**TRANSPORTATION RESEARCH BOARD**
OF THE NATIONAL ACADEMIES

September 8, 2003

This letter is the first report of the Transportation Research Board's (TRB's) Committee for Review of Travel Demand Modeling by the Metropolitan Washington Council of Governments (MWCOG). The committee, appointed by the National Research Council to undertake this review, includes both scholars and practitioners, who collectively are familiar with MPO modeling practices in many areas of the country. The committee's membership is listed in Attachment 1.¹

Figure 1. Freeway and expressway link speeds before (*initial*) and after (*final*) spreading.

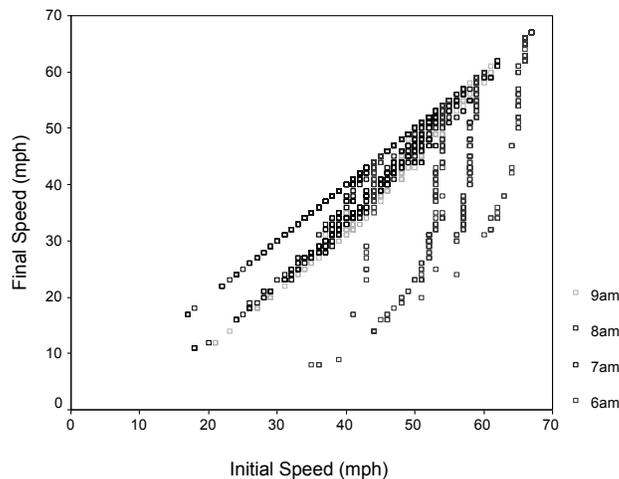
Considering only the four hours from 6 am to 10 am, TPB’s procedure does yield speed estimates conforming to TPB’s expectations, i.e., initial speeds are higher than the final estimated (postprocessed) speeds (see Figure 1).

Speeds in the initial hour in which spreading occurred (8 am) are generally the same before and after postprocessing. In contrast, speeds estimated for the shoulder hours drop after postprocessing. Evidence of spreading beyond the shoulder hours can be seen in the 6 am results, where speeds drop substantially after postprocessing.⁵⁰

Figure 2a. NOx composite freeway stabilized emission rates for Alexandria.

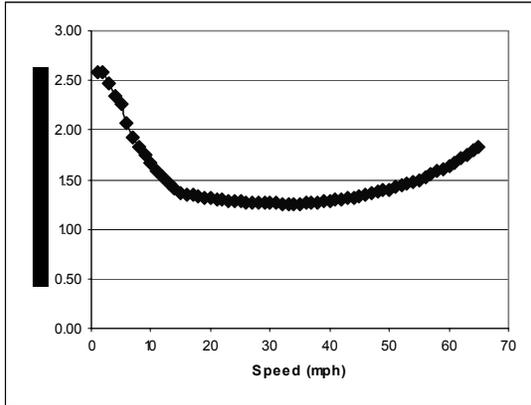
To gain some insight into the potential effect of change in speeds on emissions, committee members made a simplistic assumption that the Alexandria NOx composite running emission rates, which were provided by TPB in earlier documentation,⁵¹ could be used to approximate possible trends in emissions. Figure 2a shows the relationship of NOx emissions rate and speed. NOx emission rates are greatest on these links at lower and higher speeds.

Figure 2b. Emission rates assigned by speed before (*initial*) and after (*final*) postprocessing.

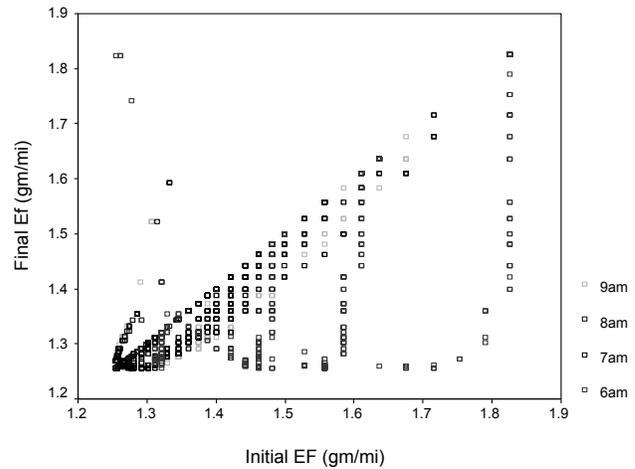
Figure 2b shows the initial and final running emission rates (i.e., assigned by speed) estimated for the freeway/expressway links. The initial emission rates that would have been assigned had there been no smoothing after assigning 24-hour volumes to an hourly profile are generally lower than final rates based on postprocessed speeds, because the reduced speeds after postprocessing fall into the speed range where the emissions rate is increasing with speed (Figure 2a). Thus, while TPB’s postprocessing procedure estimates speed conservatively, the overall effect could be to reduce emissions estimates. Many of the links on which peak spreading occurs are not in the City of Alexandria and consequently might have a different profile of composite running stabilized emission rates, but we would not expect the overall pattern to be markedly different.

In interpreting Figure 2b displaying NOx emissions rates in its report, the TRB Committee states that *“The initial emissions rates that would have been assigned had there been no smoothing after assigning 24-hour volumes to an hourly profile are generally lower than final rates based on post-processed speeds, because the reduced speeds after post-processing fall into the speed range where the emissions rate is increasing with speed (Figure 2a).”* As discussed in the previous paragraph, TPB staff believes that the opposite is the case; that is, under the conditions described here initial NOx emissions rates are generally higher than final rates because the post-processing procedure is properly reflecting the fact that at the high end of the speed range, (*“where the emissions rate is increasing with speed,”*) increasing volumes in an hourly time period will result in reduced speeds and reduced NOx emissions rates.
